**FIRST ADDENDUM  
TO  
THIRD AMENDMENT TO THE ASSIGNMENT AND ASSUMPTION AGREEMENT**

This **FIRST ADDENDUM TO THE THIRD AMENDMENT TO THE ASSIGNMENT AND ASSUMPTION AGREEMENT** (this "Addendum") is made and entered into as of November 15, 2012, by and between the Virginia Department of Transportation (the "Department"), an agency of the Commonwealth of Virginia (the "Commonwealth"), Alpha Natural Resources, LLC ("Alpha"), and Rapoca Energy Company, formerly known as Pioneer Group, Inc. ("Rapoca"). This Addendum supplements and is made a part of that certain Third Amendment to the Assignment and Assumption Agreement, dated December 5, 2011, by and among the parties hereto (the "Third Amendment"). Capitalized terms not otherwise defined herein shall have the meaning given to them in the Third Amendment.

**SCHEDULE 3  
EXHIBIT 1 (REVISED): GEOGRAPHICAL DELINEATION MAP**

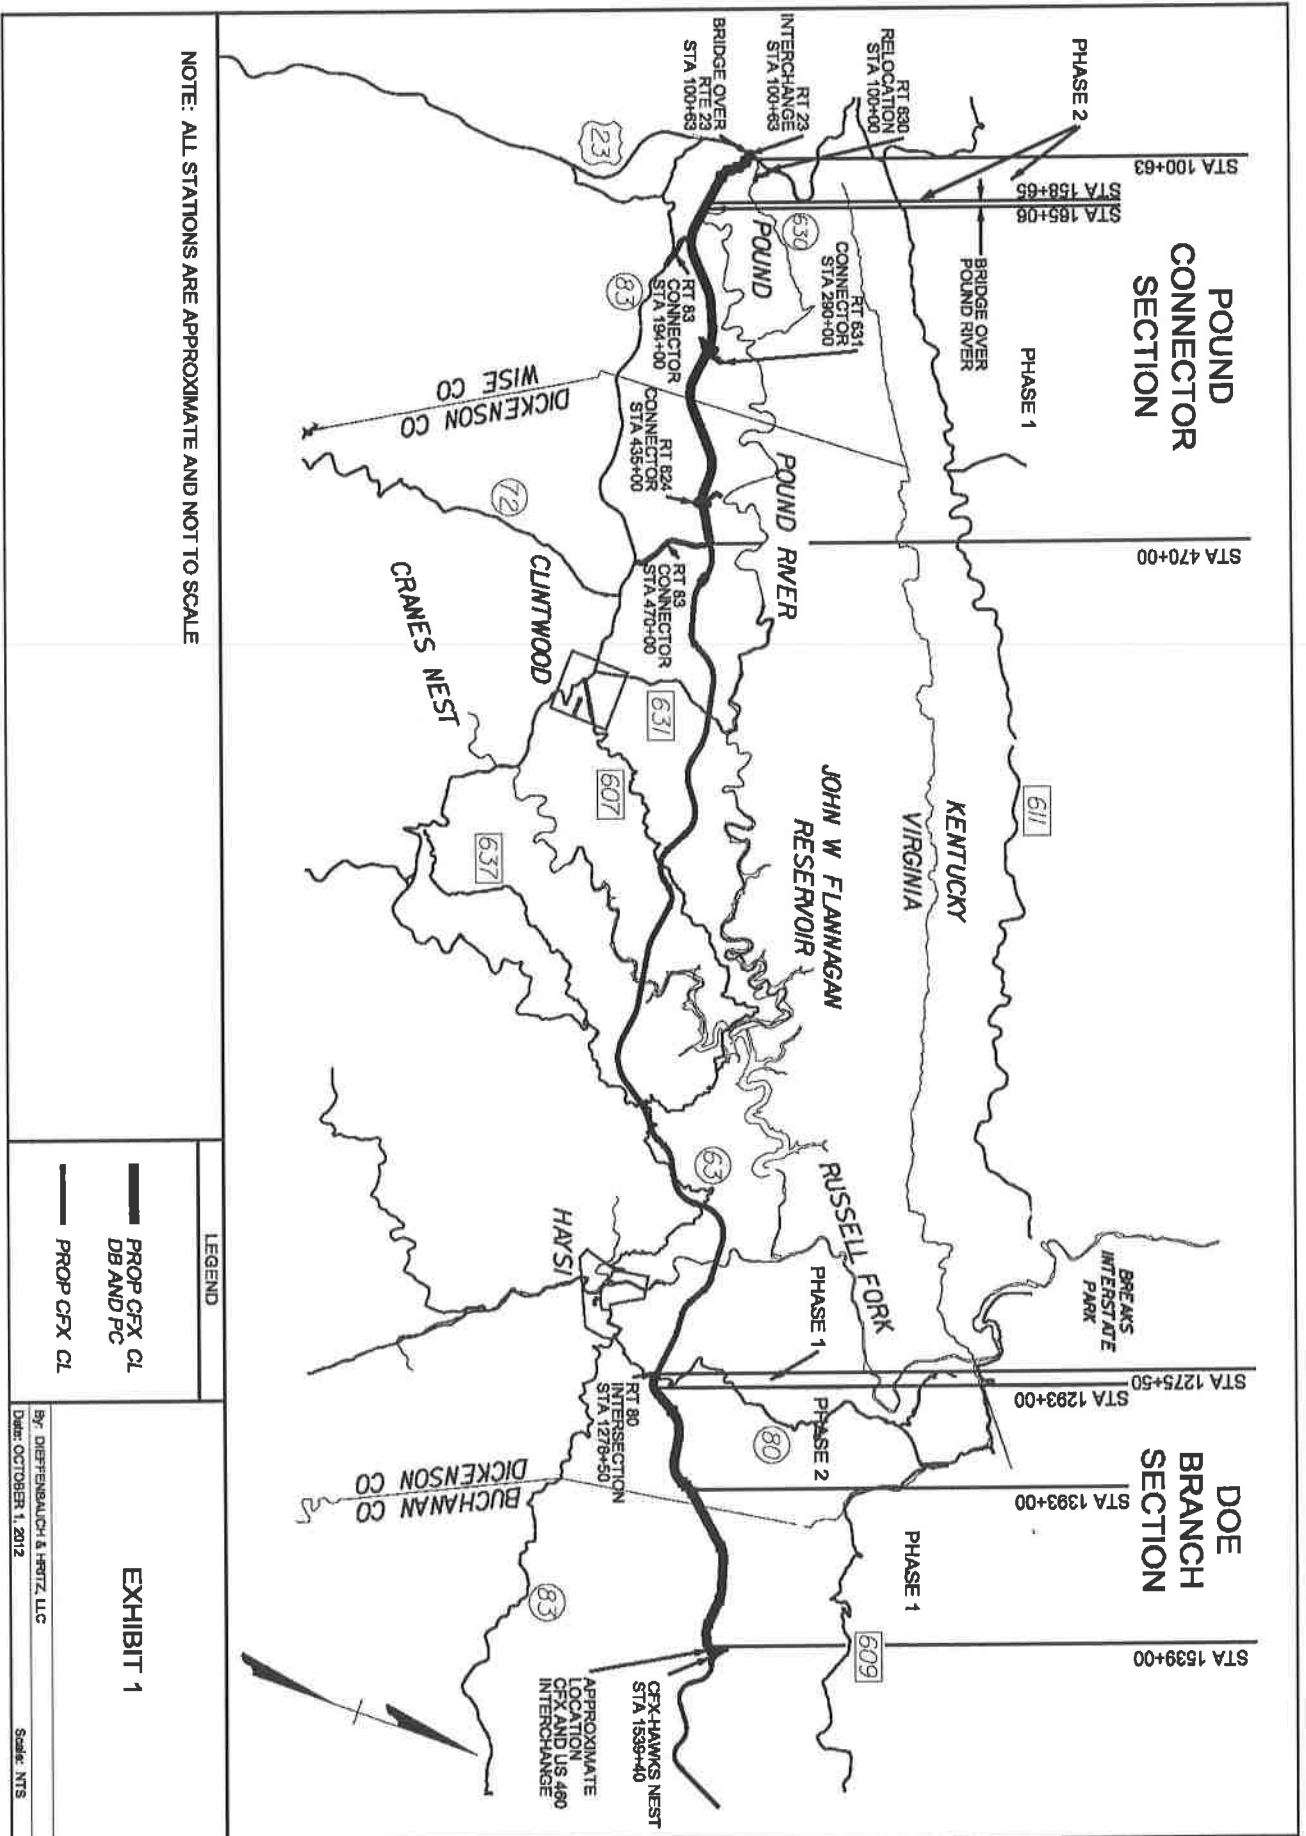
7. **Exhibit 1.** Exhibit 1 to the Third Amendment shall be replaced with the revised Exhibit 1 attached to this Addendum as Schedule 3.
